SPECIALIST COMMENTS RESPONSE – SUNFIELD PROJECT

Further to your recent instructions, we have reviewed comments received on 4 August 2025 and have responded to the transport matters raised.

Figure 2: City Rail Link Map

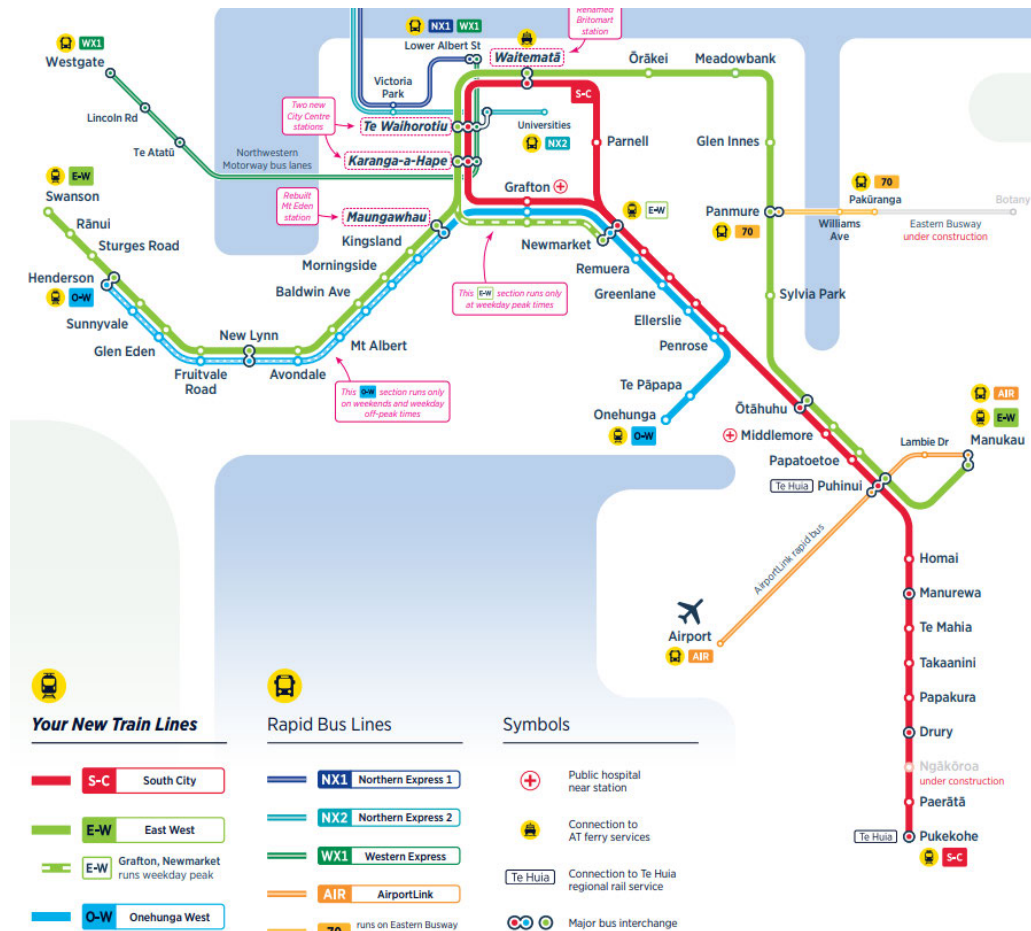
Comment:

It is additionally noted that the City Rail Link (CRL) project is on track to be completed in 2026¹ which will increase capacity of the network, provide more options for travel, and greater service frequency.

The Sunbus will enable direct / frequent connection from the site to the southern rail line utilising the benefits of CRL.

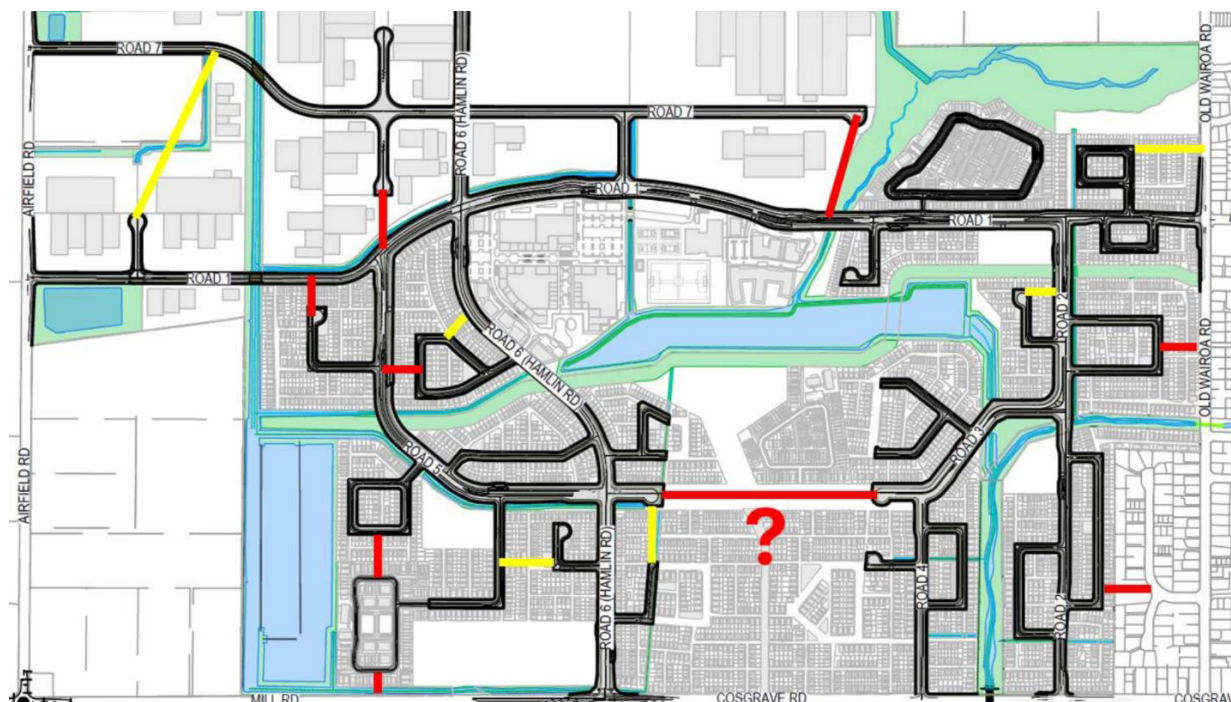
In this regard 8m wide road to road accessways (as per AT's design standards) is recommended. The recommended road to road accessway locations is provided in the red lines on Figure 4 below. The connections offer significantly reduced travel time around the neighbourhood and key destinations. The yellow lines in Figure 4 below indicate where these connections could be beneficial, where the applicant can investigate providing a connection through an accessway or easement.

Please refer to the Urban Design Masterplan Report.

Figure 3: Internal Active Mode Connections

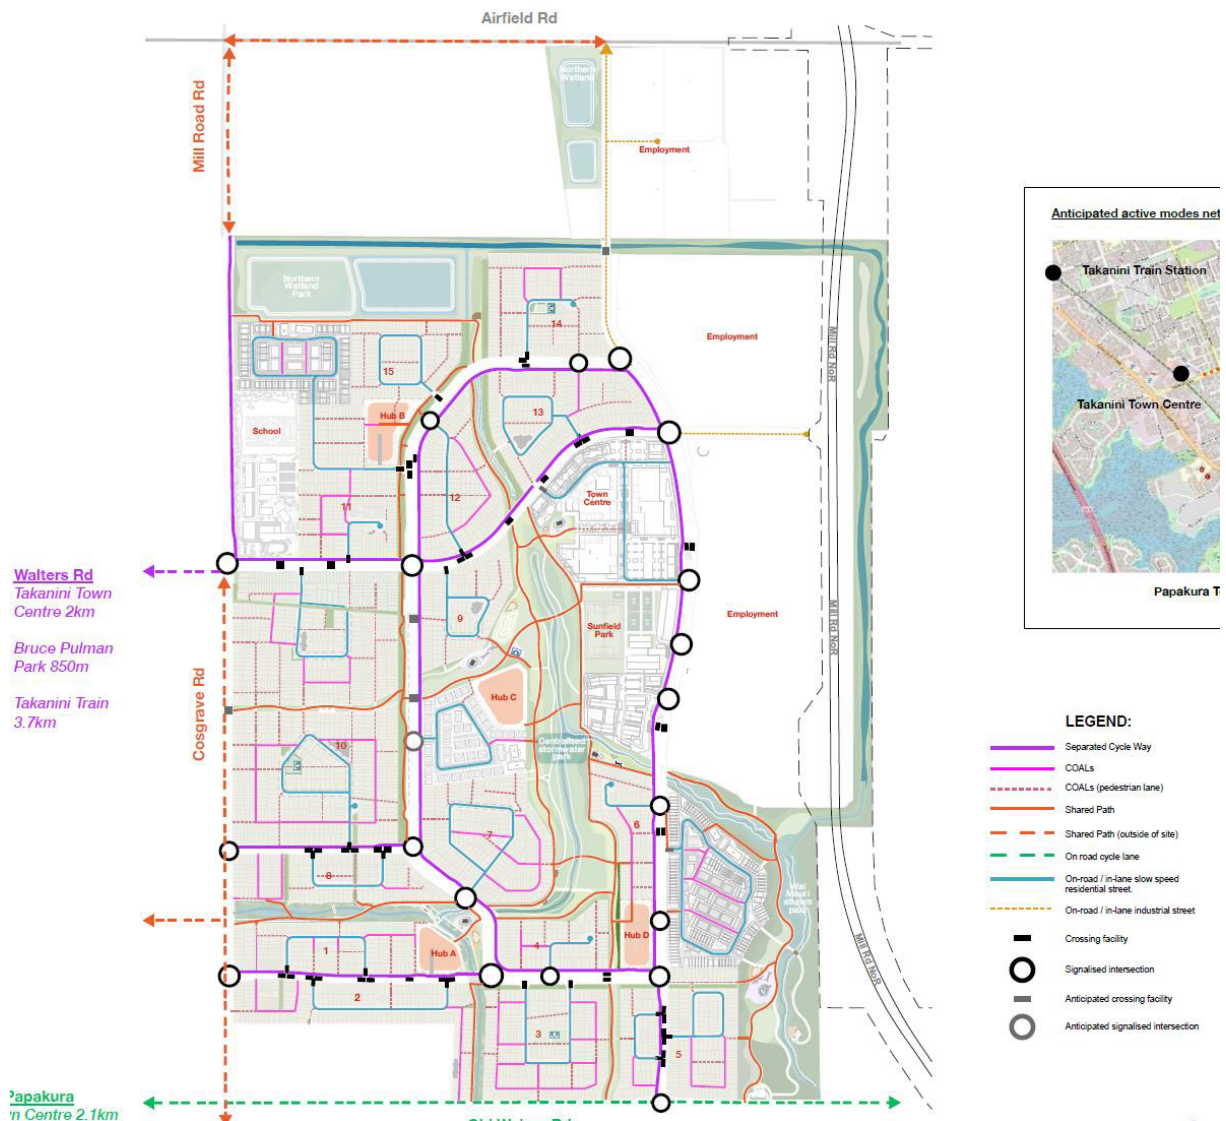
There will likely be other private connection (e.g. the school on Cosgrave Road) in addition to those shown in Figure 7.2 of the ITA. It is noted that Figure 7.2 of the ITA does not show a fourth connection which is proposed being Road 6 (Hamlin Road) which is proposed to now have a separated cycleway on the northern side of the road.

Figure 3 highlights the proposed internal active mode connections, which are planned to connect with the proposed partly developer constructed cycle connections providing adequate active mode connections to the wider network.

Please refer to the Cycle/Active Mode network plan which is detailed below and accompanies this response.
